DEVELOPMENT CONTROL BOARD

MINUTES

Minutes for a meeting of the Development Control Board held on Thursday, 14th December 2023 at 9:00 AM at the District Administration Conference Room, District Administration Building, Cayman Brac.

DCB/16/23

Figure 2. The application site with parcel boundary highlighted in red and an overlay of the proposed development plans (Aerial Imagery Source: UKHO, 2021 & Development Plans Source: George Manderson Jr., 2023).

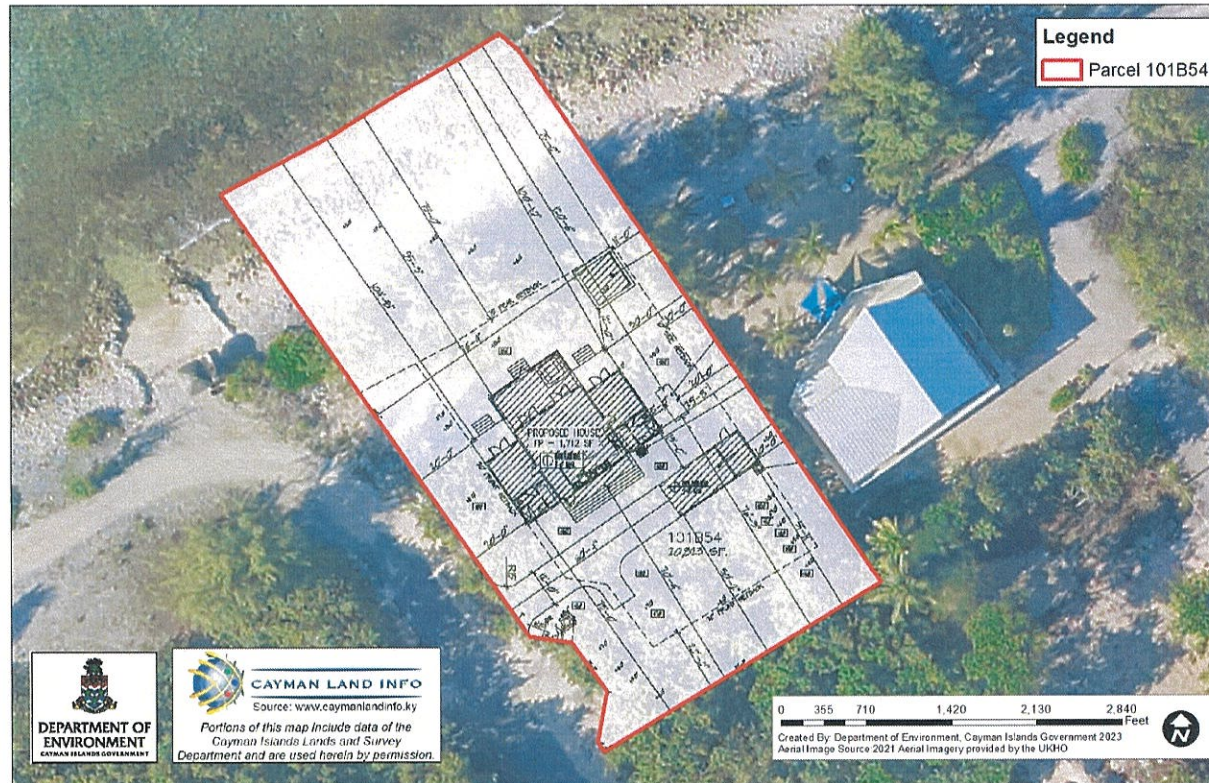
It is likely that beach-quality sand will be excavated for the construction of the proposed development. Loss of sand from the beach system reduces the volume of sand available to replenish the beach naturally. It disrupts the delicate equilibrium of sediment transport along the coast, ultimately contributing to the erosion of the beach and the loss of valuable coastal ecosystems and infrastructure. As a limited and precious resource, the sand should stay within its natural beach system. However, if the sand is proposed to leave the site and be lost from the beach system here, the Development Control Board should retain appropriate development control over where the beach sand will be placed.

- 1. Any beach quality sand excavated during construction shall be retained on-site and placed along the active beach profile. If there is an excessive quantity of sand that cannot be accommodated on-site, and the applicant would like to move sand off-site, it should be the subject of a separate consultation with the Planning Department and National Conservation Council.*

Figure 1. The accommodation block (red) and the new school (blue) (Aerial Imagery Source: UKHO, 2021)

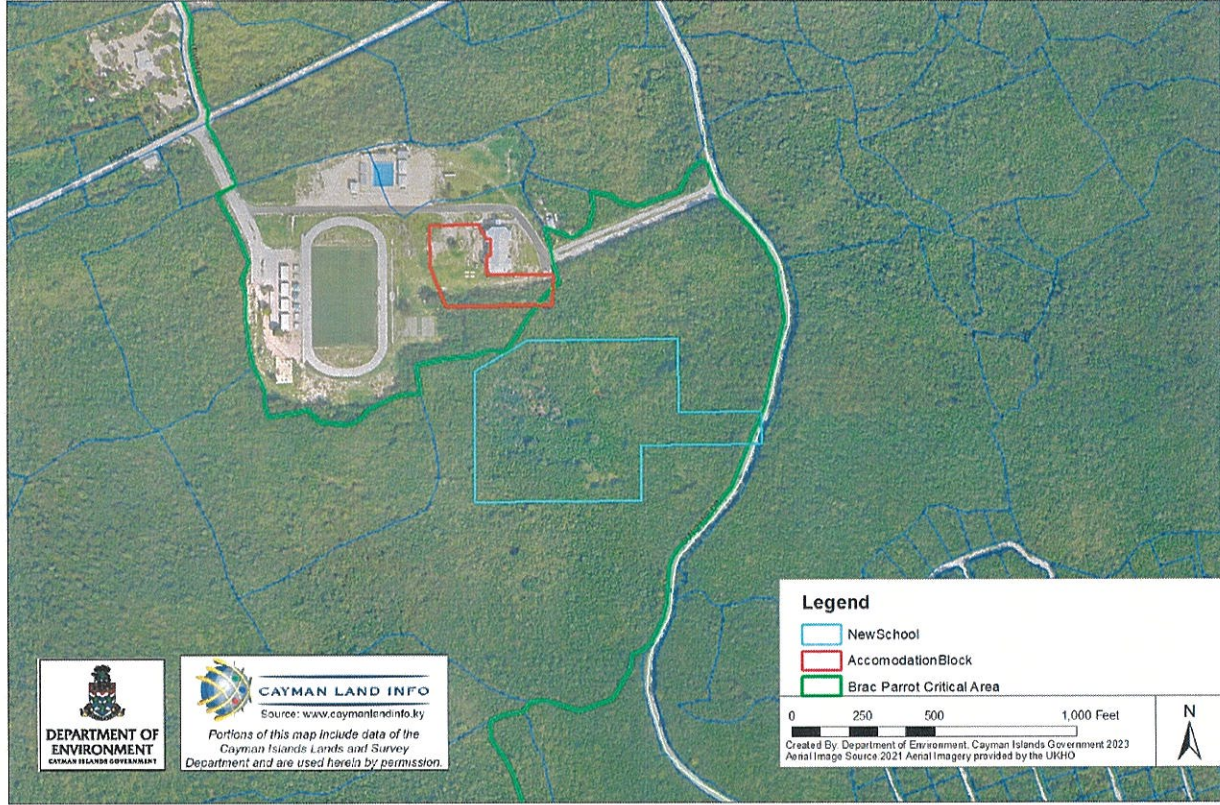
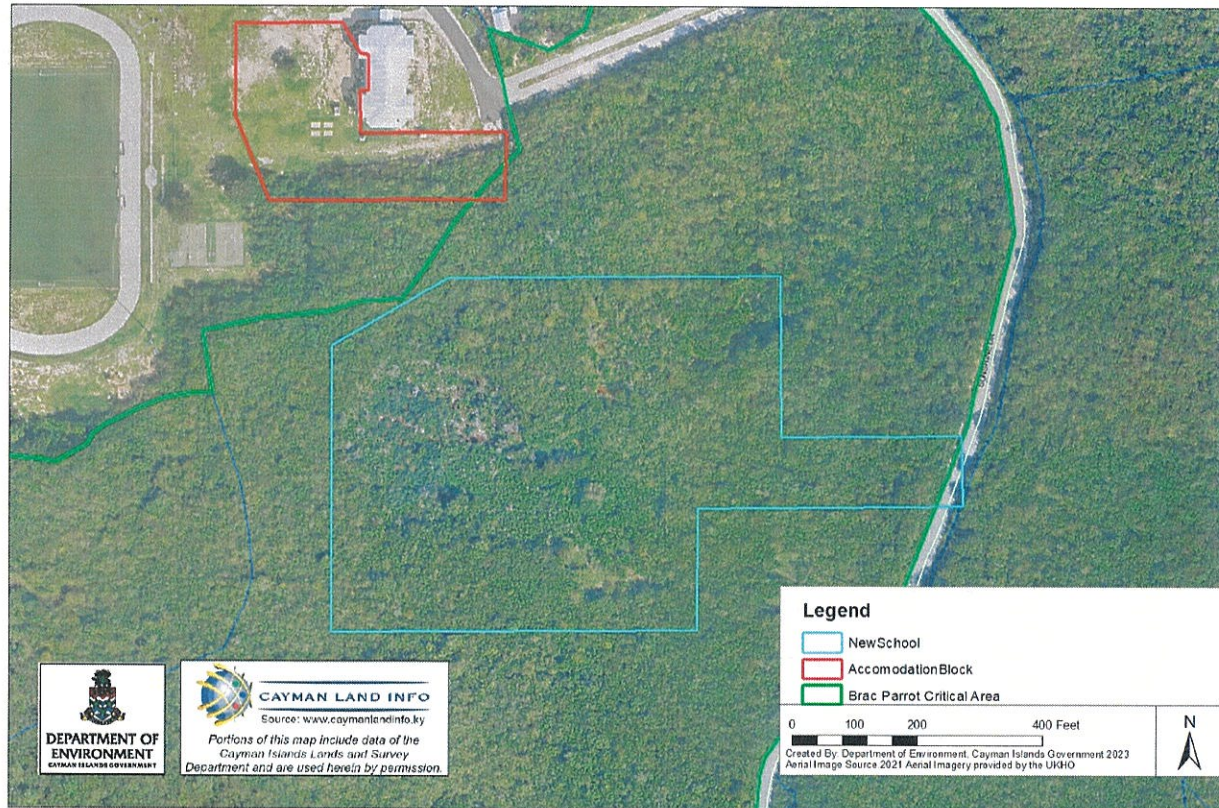
The accommodation block has been set within a man-modified area that appears to have been mostly cleared and is of limited ecological value. The new school is within a partially man-modified area with extensive regrowth (see Figures 1 and

The applicant should retain as much native vegetation as possible and incorporate it into the landscaping scheme. Primary habitat and native vegetation can be retained and used in a variety of ways on a property:

Figure 1: Land cover map of the subject parcel (Source: DoE, 2013)

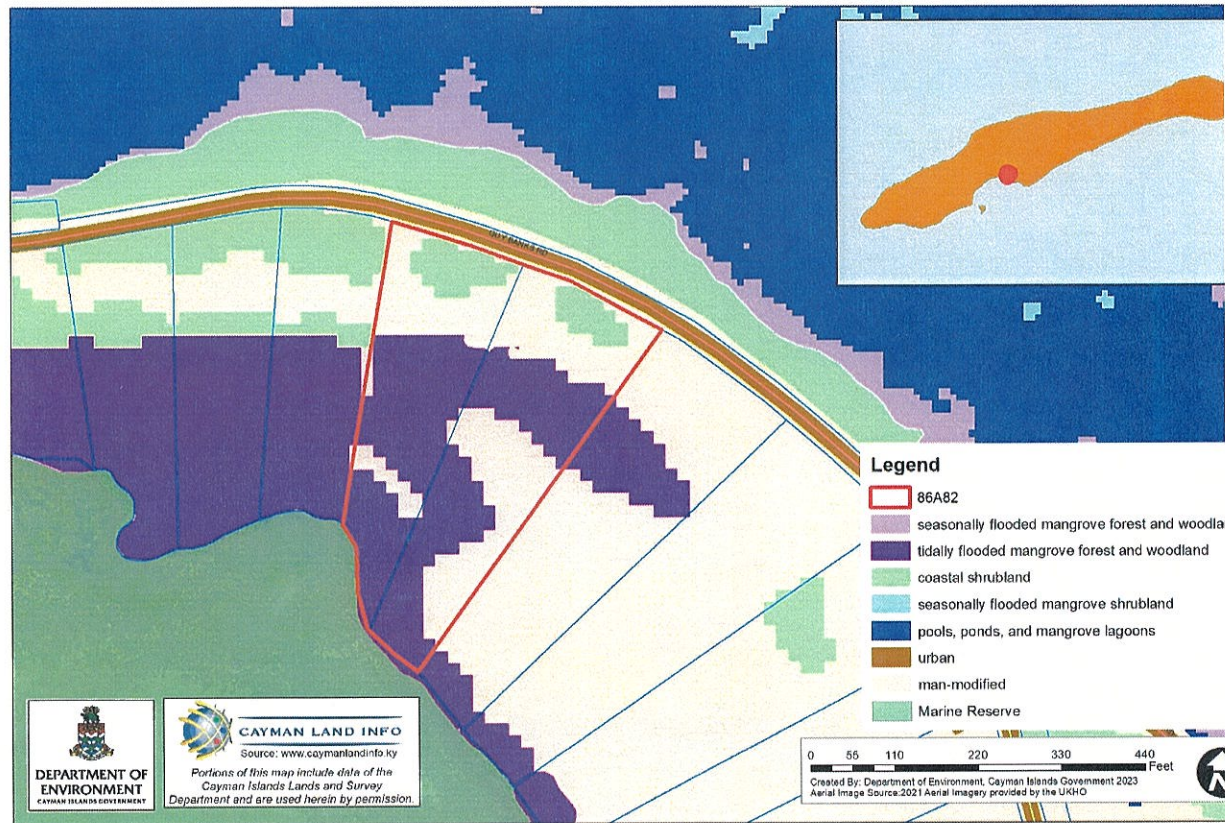
"The majority of the site is man-modified habitat however it contains a significant amount of tidally flooded mangrove forest, as shown in Figure 1.

Mangroves provide a nursery habitat for fish and other marine life and are vital in helping to maintain good water quality. Studies have demonstrated the importance of the presence of these fringing mangroves on the health of nearshore marine ecosystems.¹ Mangroves are also important as a natural buffer to help mitigate coastal and storm-derived impacts such as flooding and shoreline erosion. Mangroves are Part 2 Schedule 1 protected species under the National Conservation Act (2013) with an adopted Mangrove Conservation Plan (2020). It is an offence to remove mangroves unless permission is explicitly sought to remove them either through a coastal works permit, planning permission or a National Conservation Council Section 20 permit. We appreciate that the applicant took the opportunity to consult with the DoE prior to submitting the application to reduce negative impacts to this important ecosystem. As per the applicant's calculations, the works will affect less than 9% of the total fringing mangrove on the property, with 91% being preserved.

Figure 2: Proposed site plan (Source: Submitted Plans [1/6] / Aerial Imagery Source: UKHO, 2021)

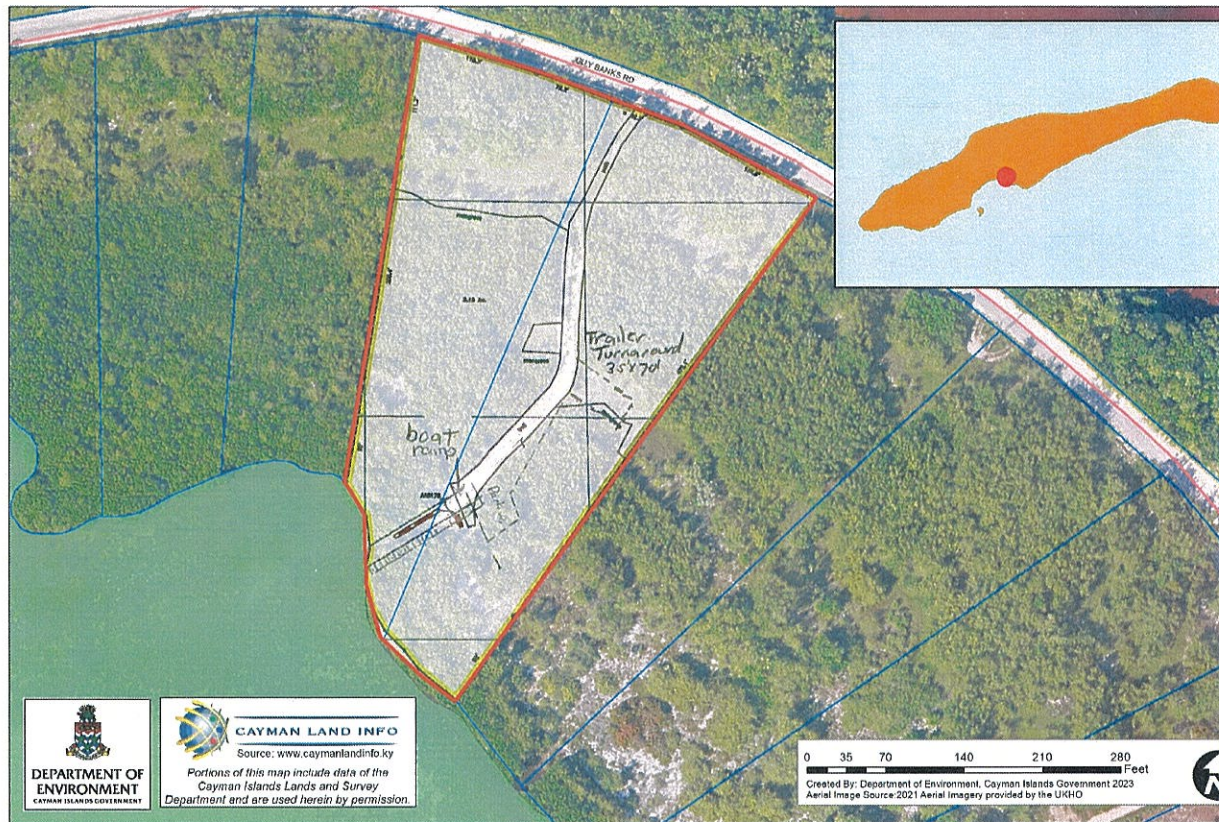
While we do not support the practice of cutting through the mangrove fringe to access South Hole Sound, the DoE notes that the proposed boat ramp and access road are in line with a road that has already been constructed down to the water's edge, and a channel that has already been cut in the fringing mangroves. As such, the location has already been impacted and therefore the impact associated with the proposed boat ramp is lower than if a pristine location had been chosen.

Care should also be taken during excavation of the channel for the boat ramp and placement of the rock fill for heavy equipment such that the extent of the impact to mangrove vegetation is limited to only that required for the construction of the boat ramp. The applicant indicates in their cover letter that they intend to keep the remainder of the property as natural as possible, including planting native vegetation. This is a practice that the DoE strongly supports.

Figure 1: Landcover map for 102A237, outlined in blue (DoE, 2013)

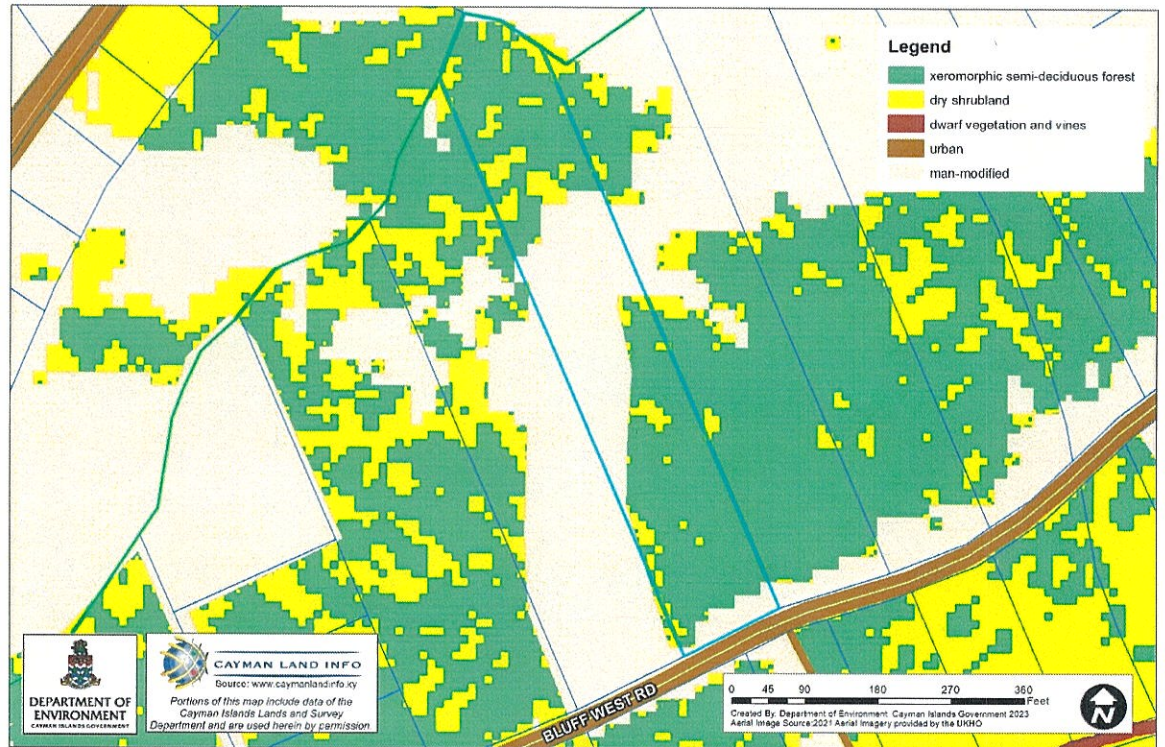
The application site consists of a mixture of primary xeromorphic semi-deciduous forest and primary dry shrubland habitat, along with man-modified areas (refer to Figure 1). Primary habitat is mature habitat in its natural state, otherwise uninfluenced by human activity where ecological processes are not significantly disturbed. These habitats are often very old, existing long before humans and may consist of many endemic and ecologically important species.

Primary habitat is in severe decline and becoming a scarce and highly threatened resource as a result of land conversion for human uses. For this reason, the DoE does not support speculative or wholesale clearing of subdivision sites. In principle, land clearing should be reserved until the development of individual lots is imminent (through the granting of planning permission for development on those particular lots). This allows the opportunity for the individual lot owners to retain as much native vegetation as possible. Native vegetation is best suited for the habitat conditions of the site and requires less maintenance which makes it a very cost-effective choice.

Figure 2: Parcels under 2 acres with no structures present as of 04 Nov. 2021 (DoE, 2021)

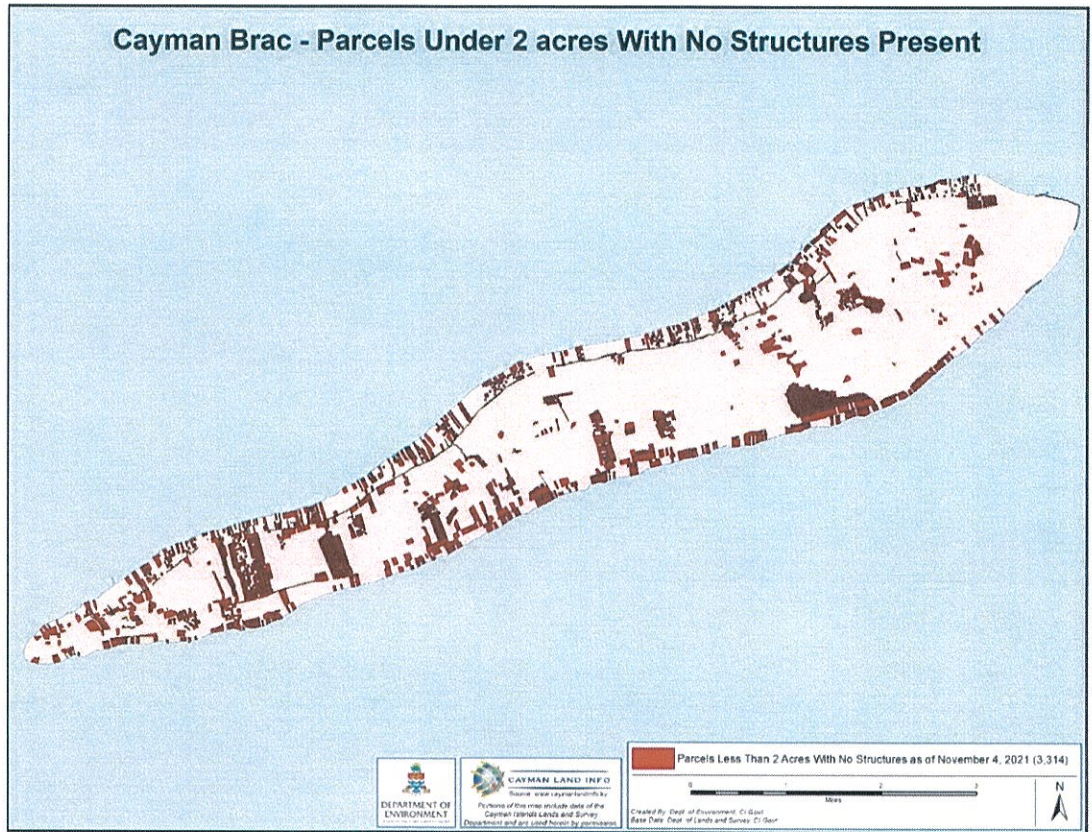
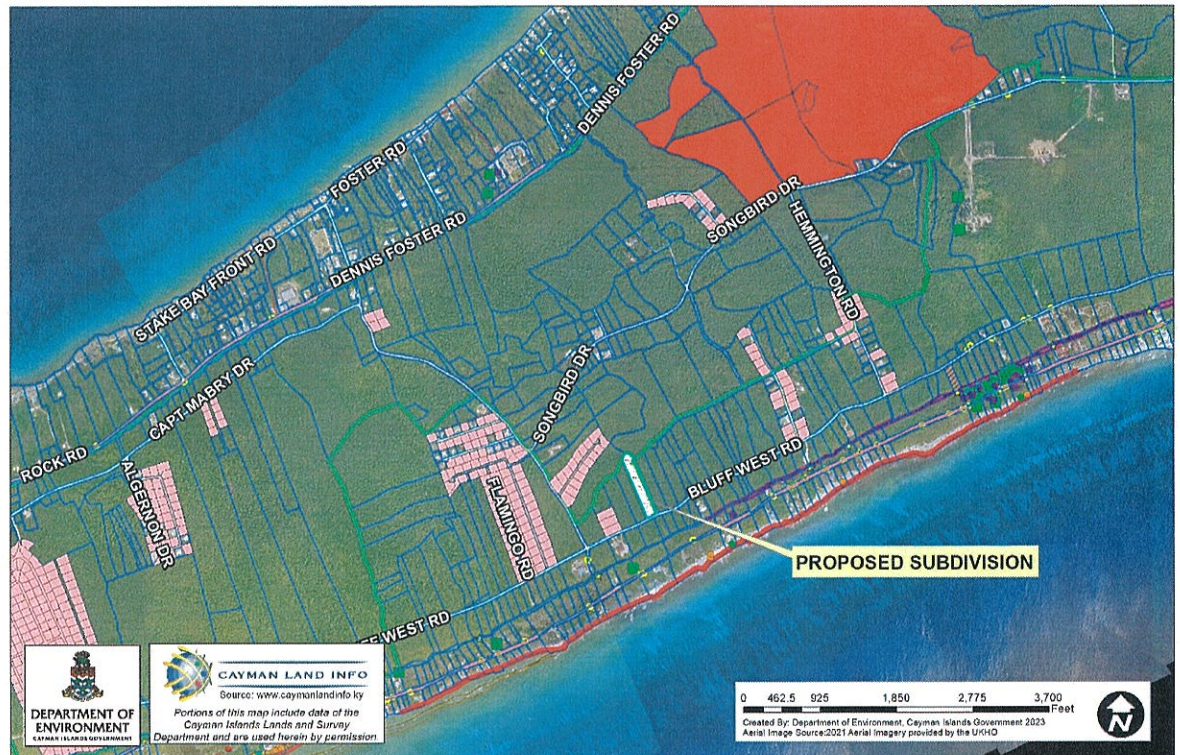
the number of subdivision applications which have been approved since this figure was last updated, the number of undeveloped subdivision lots has likely only increased. Figure 3 shows the proposed subdivision in relation to the similar, yet undeveloped subdivisions that make up much of the surrounding area.

The overall impact on the infrastructure and population of Cayman Brac should be considered given the scale of the existing parcellation of the island. Hypothetically, should each of the 3,314 subdivision parcels be developed for housing, this could result in a population increase of 6,620+ people for Cayman Brac. This would more than triple the current combined population of the Sister Islands, taking the estimated population from 2,257², to 8,877+ people (working on an estimate of two persons per household). With nearly four times as many inhabitants, there would be significant pressure on the infrastructure and amenities on the island, which should be assessed within the context of a Development Plan for the island. Against this background, the need for further residential housing development lots should be robustly justified.

- *There shall be no land clearing, excavation, filling or development of the resultant parcels without planning permission for such works being granted.*
- *Any future development, clearing, filling or excavation of the resultant subdivided parcels shall be the subject of a separate consultation with the Development Control Board and National Conservation Council."*

Figure 1: The application site outlined in red in relation to important habitat for Cayman Brac Parrot and the Sister Islands Rock Iguana plateau (Image Source: UKHO, 2021).

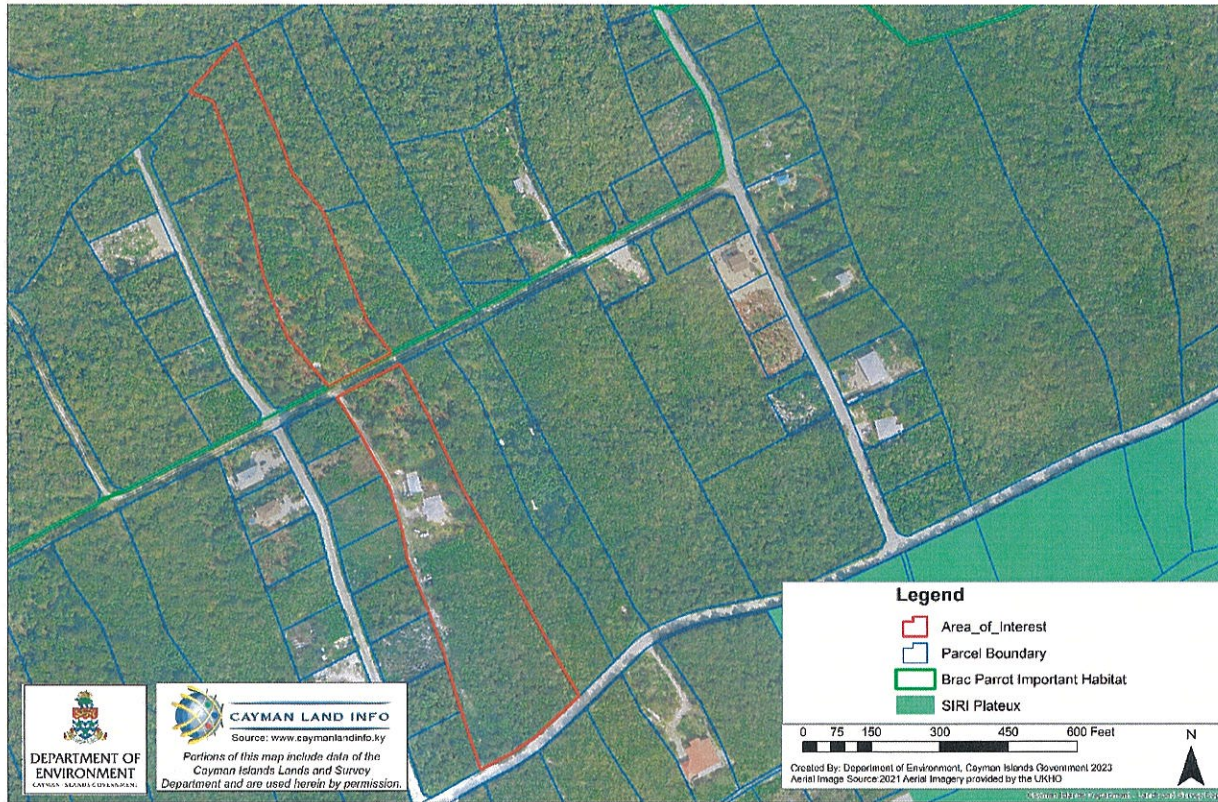
The application site consists of primary and secondary xeromorphic semi-deciduous forest. The site is also partly located in an area which is known to be important Cayman Brac Parrot (*Amazona leucocephala hesterna*) habitat and is in close proximity to the Sister Island Rock Iguana plateau as shown in Figure 1.

We note that the application is for a subdivision, we would **not** support the clearing of this site at this time. Land clearing should be reserved until the development of individual lots is imminent (through the granting of planning permission for development on those particular lots). This allows the opportunity for the individual lot owners to retain as much native vegetation as possible. Clearing the entire site prematurely removes the choice from the individual lot owners and removes the value the habitat could provide in the time between the preparation of a subdivision and the development of an individual lot.

Jackhammering and operating heavy machinery is not safe for nesting iguanas. Construction works not only disturb the physical iguana nesting habitat but heavy machinery and associated works can crush or bury iguanas and their nests. The DoE does not support the wholesale clearing of subdivision sites or speculative clearing. The clearing and filling of the site could bury iguanas or their nests. If the applicant decides to clear and fill any part of the site, it should be subject to a separate planning application and not take place between 1st May and 30th September each year.

There shall be no land clearing, excavation, filling or development of the resultant parcels without planning permission for such works being granted."
